# SERVICE BULLETIN

B-086

Safety Recall Code 0837

## BUELL SAFETY RECALL 0837 XB12XT/P WINDSHIELD KIT

**Figure 1. Windshield Removal**

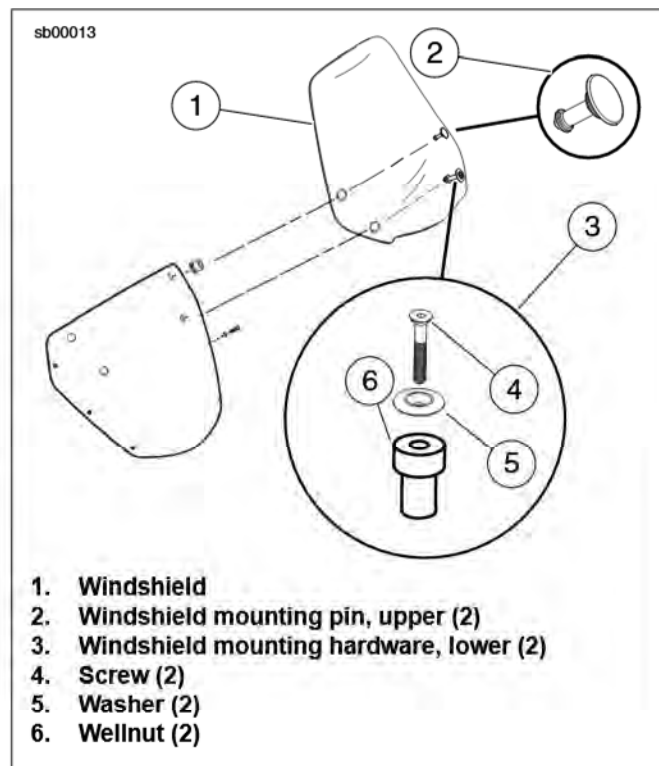
See Figure 1. The windshield is secured to the windscreen using two screws (4) with well nuts (6) and two mounting pins (2).

After removing the lower windshield mounting hardware, it will be necessary to pull the windshield loose from the windscreen by pulling upward sharply at the upper mounting pins.

1. Remove windshield mounting hardware (3) securing the windshield to the windscreen and pull windshield from windscreen. Discard lower windshield mounting hardware.
2. Pull windshield loose from the windscreen by pulling upward sharply at upper mounting pins.
3. Remove six fasteners from windscreen, and remove windscreen from motorcycle.

Figure 2. Windshield Installation

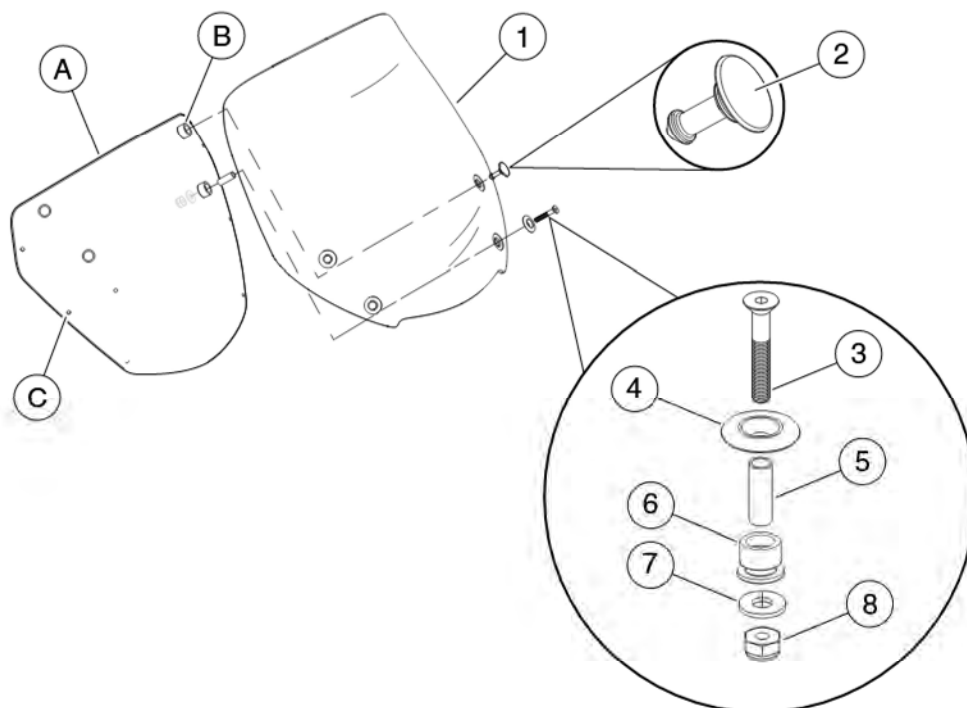
Windshield **MUST** be installed to windscreen while both components are off motorcycle. Lower fasteners can not be installed if windscreen is installed on motorcycle.

1. See Figure 2. Install windshield (1) by pushing upper mounting pins (2) into place. Verify upper mounting pins on windshield locate properly into upper bodywork mounting grommets (B) of windscreen (A).
2. Align lower windscreen (A) and windshield holes. For left and right side lower holes, insert finish washer (4) and spacer (5) onto screw (3) and place through windshield, grommet, and windscreen holes.
3. Install bodywork mount grommets (6) from kit into lower holes in windscreen.
4. From inside of windscreen, place washer (6) onto screw (3) and thread lock nut (7) onto screw. Tighten screw to 25-30 in-lbs (2.8-3.4 Nm).
5. Install windscreen (A) (with windshield attached) using six screws removed earlier. Tighten screws to 10-12 in-lbs (1.1-1.4 Nm).
